SERVICE BULLETIN

| RE: | THROTTLE MECHANISM NOISE | PRODUCT | P |
| | B 20 B, -E, -F | GROUP | 27 |
| DATE | August 28, 1973 | NO. | 5 |

Throttle linkage (carburetor engines and automatic transmission)

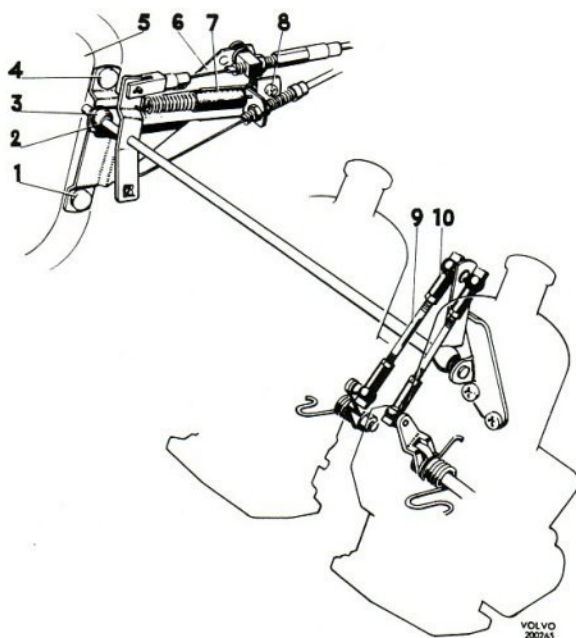
Following alterations have been introduced on the production line in order to prevent noise from the throttle.

The throttle mechanism has been provided with plastic ball joints, plastic bushing for bracket and a new type bracket. The return spring has in B20 B been provided with a rubber cover (pos. 7 in the sketch).

1973 models with noisy throttle linkages can be remedied by installing following parts:
